Access Compliance Report

Public Rights-of-Way

(Curb Ramps)

Intersection ID: 53288	Main Street: PROSPERITY_CHURCH_RD	Cross Street: ROBERT_HELMS_RD	Location: SE
ADA ID: 3917CC15F458	Ramp Type: BlendTrans1	Initial Pass/Fail: Pass	Overall Compliance: No
Severity Score: 5			
Codes/Mitigation Info/Possible Solution		Field Measurements/Component Compliance

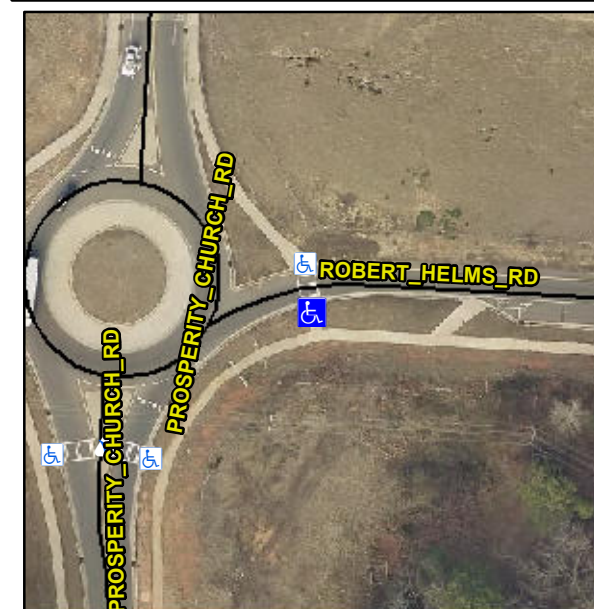
R305.2, R304.5.4

Compliance	Description	Data	Compliance	Description	Data
N/A	Ramp Length (in)	109.0	Yes	BlendTrans Slope (%)	4.7
Yes	Ramp Width (in)	48.0	Yes	BlendTrans XSlope (%)	0.2
N/A	Flare Type LT	Sloped	N/A	Flare Type RT	Sloped
N/A	Flare Slope LT (%)	8.7	N/A	Flare Slope RT (%)	4.7
N/A	Flare Traversable LT?	No	N/A	Flare Traversable RT?	No
Yes	Landing Length (in)	58.0	Yes	DWS Provided?	Yes
Yes	Landing Width (in)	72.0	Yes	DWS Contrast?	Yes
Yes	Landing Slope (%)	0.5	Yes	DWS Length (in)	24.0
Yes	Landing X Slope (%)	0.5	Yes	DWS Full Width?	Yes
N/A	Landing Curb? (Y/N)	No	No	DWS Offset (in)	3.0
N/A	Shared Landing?	No			
Yes	Gutter Ponding?	No	No	Gutter Slope (%)	5.5
Yes	Gutter Lip Ht (in)	0.0	Yes	Gutter X Slope (%)	1.7
N/A	Painted X Walk1?	Yes	N/A	Painted X Walk2?	N/A
	X Walk 1 Direction	To NW		X Walk 2 Direction	N/A
	X Walk 1 Width (in)	105.0		X Walk 2 Width (in)	N/A
	X Walk 1 Slope (%)	3.1		X Walk 2 Slope (%)	N/A
	X Walk 1 X Slope (%)	0.1		X Walk 2 X Slope (%)	N/A

Yes	Ramp inside XWalk1?	Yes	N/A	Ramp inside XWalk2?	N/A
	Road Slope (%)	0.1		Clear Space?	Yes
	Road X Slope (%)	3.1	N/A	Clear Space to XWalk (in)	N/A
Yes	Any Obstructions?	No	Yes	Storm Grate/Utility Hazard?	No
	Obstruction Type			Storm Grate/Utility Type	
		N/A			N/A
			Yes	Surface Condition? (G/P)	Good
			Yes	Curb Slope (%)	4.7

Remove & Replace Detectable Warning System. Remove & Replace Gutter.
